Access Compliance Report Public Rights-of-Way (Curb Ramps)

Main Street: ROOSEVELT_AVE Cross Street: WILSON_ST Location: NW

ADA ID: RPRK211001141309 Ramp Type: Type 1 - Perpendicular Diagonal Initial Pass/Fail: Pass Overall Compliance: No Severity Score: 10

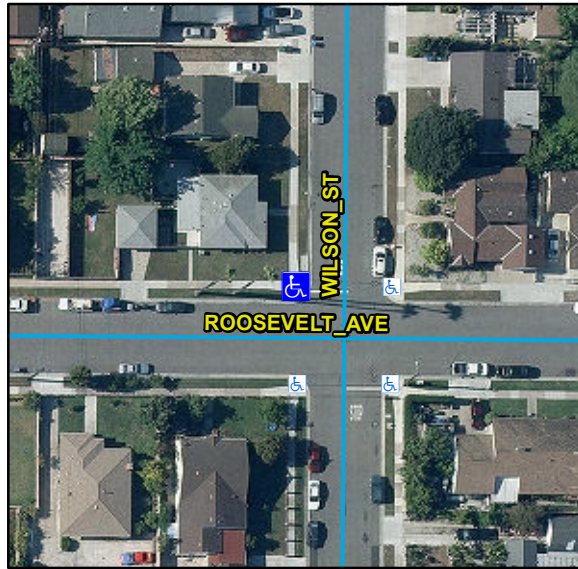
R304.2.2, R304.2.1, R304.2.2-Perp, R304.3.2-Para, R304.5.3, STD 1115

Compliance	Description	Data	Compliance	Description	Data
N/A	Ramp Length (in)	95	N/A	Flare Type LT	
Yes	Ramp Width (in)	48			Sloped
Yes	Ramp Run Slope (%)	4.8	N/A	Flare Slope LT (%)	4.9
Yes	Ramp Cross Slope (%)	1.9	N/A	Flare Traversable LT	No
N/A	Landing Present	No	N/A	Flare Type RT	
N/A	Landing Length (in)	N/A			Sloped
No	Landing Width (in)	N/A	N/A	Flare Slope RT (%)	4
No	Landing Run Slope (%)	N/A	N/A	Flare Traversable RT	No
No	Landing Cross Slope (%)	N/A	Yes	DWS Provided	Yes
N/A	Landing Movement Obstructed?	Yes	Yes	DWS Contrast	Yes
	Landing Movement Type	Curb	Yes	DWS Length (in)	37
N/A	Landing Shared	N/A	Yes	DWS Full Width	Yes
N/A	Clear Space	Yes	Yes	DWS Offset Left (in)	0
N/A	Clear Space To Crosswalk (in)	48	Yes	DWS Offset Right (in)	N/A
N/A	Marked Crosswalk 1	No	N/A	Marked Crosswalk 2	No
	Crossing 1 Direction	S		Crossing 2 Direction	E
	Marked Crosswalk 1 Width (in)	N/A		Marked Crosswalk 2 Width (in)	N/A

N/A	Ramp Inside Crosswalk 1	N/A	Yes	Ramp Inside Crosswalk 2	N/A
	Crossing 1 Slope (%)	4.8		Crossing 2 Slope (%)	1.4
	Crossing 1 Cross Slope (%)	1.2		Crossing 2 Cross Slope (%)	2.3
Yes	Gutter Ponding	No	No	Curb Slope	10.3
Yes	Gutter Lip Height (in)	0		Road Run Slope (%)	0.5
Yes	Gutter Run Slope (%)	1.5		Road Cross Slope (%)	2.3
No	Gutter Cross Slope (%)	2.3			
Yes	Overall Surface Condition: Acceptable		Yes	Perp Joint Present	Yes
	Cross Gutter Present?	No		Spandrel Present?	No
	Replace Cross Gutter?	N/A		Replace Spandrel?	N/A

Remove & Replace Curb Ramp With Two New Directional Ramps or Equivalent. Remove & Replace Gutter.
